UNITED STATES PATENT AND TRADEMARK OFFICE

| APPLICATION NO. | FILING DATE | FIRST NAMED INVENTOR | ATTORNEY DOCKET NO. | CONFIRMATION NO. |
|--|-------------|----------------------|-----------------------------|------------------|
| 10/565,690 | 01/24/2006 | Claude Baudrenghien | 1717214 | 2525 |

| Office Action Summary | Application No. 10/565,690 | Applicant(s) BAUDRENCHIEN ET AL. | |

DETAILED ACTION

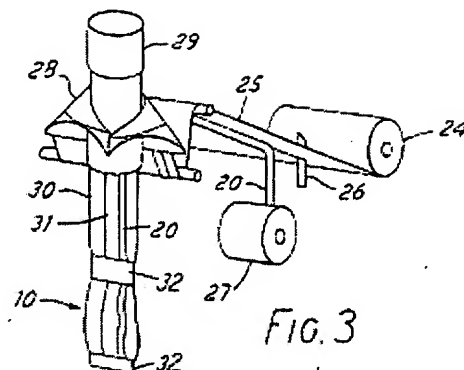
Regarding claim 1, Sanders ('399) teaches an air-tight package comprising a flexible air- tight envelope (*FIG-1, #10 and col. 2, ll. 5-10*), of which one wall is pierced by a slot (*FIG-1, #17*), and a self adhesive strip to close the slot in the envelope (*FIG-1, #20*), wherein the self adhesive strip comprises two parallel self adhesive faces (*FIG-1, top and bottom of #19*), of which one wherein a first of the faces is completely covered with a detachable protective strip (*FIG-1, strip #21*), and of which the other wherein a second of the faces comprises a first zone that is fixed to the above mentioned wall of the envelope (*FIG-1, bottom side of #19 fixed to #14*), along a lip of the slot and a second zone that extends in front of the slot and beyond a second lip of the slot (*FIG-1, wherein #19 bridges #17*), the second zone of the self adhesive strip being covered with a detachable protective strip (*FIG-1, #19 bridges #17*).

Regarding claim 2, Sanders ('399) teaches a package wherein the envelope extends beyond the above mentioned second lip of the slot (*FIG-1, wherein #21 bridges #17*), for a distance at least equal to the a length of the above mentioned second zone of the self adhesive strip (*FIG-1, wherein #21 extends beyond #19*).

Regarding claim 3, Sanders ('399) teaches a package wherein the length of the above mentioned second zone of the self adhesive strip is at least equal to the a length of the above mentioned first zone of the said self adhesive strip (*FIG-1, wherein the length of #19 is the same length on both sides of #17*).

Regarding claims 4 and 11-12, Sanders ('399) teaches a package wherein the slot is rectilinear (*FIG-1, #17 extending below #20*).

Regarding claim 5, Sanders ('399) teaches a package wherein the slot is arranged close to the a rectilinear edge of the envelope (*FIG-1, #17 at edge of #14*).

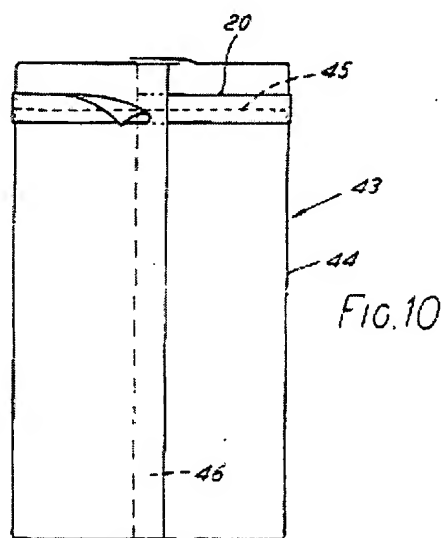
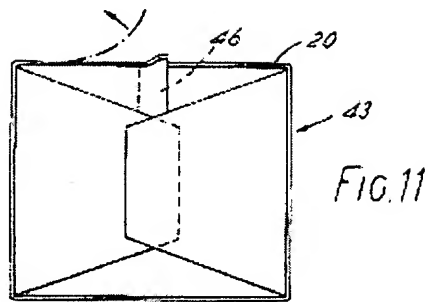
removing the protective strip from the first face of the self adhesive strip (col.4, ll. 15-26 and FIGs 10-11, #43); and

folding the envelope back on itself along the slot, so that the stripped face of the self-adhesive strip is folded back on itself (*col. 7, ll. 4-22 and FIGs 10-11, #43*).

Fig. 1

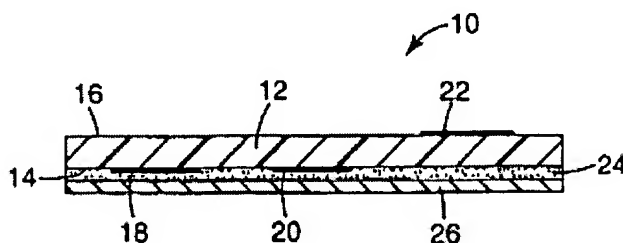
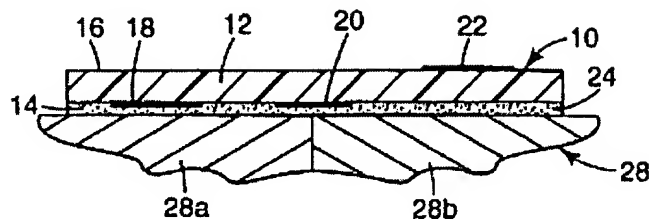
However, Cooley ('925) teaches wherein the self adhesive strip comprises at least one sheet in of synthetic olefin polymer, covered with a rubber based adhesive (*See col. 5, l. 64 to col. 6, l. 9, col. 6, ll. 42-53, col. 9, ll. 62-63 and FIGs 1 and 2, wherein label #10 with olefin film #12 having rubber based adhesive #24 backing joins components #28a and #28b.*) for the purpose of providing an adhesive that is tacky at room temperature, can be adhered to a surface by application of a light pressure and is tamper-indicating (*See col. 5, l. 64 to col. 6, l. 5 and col. 6, ll. 42-45.*).
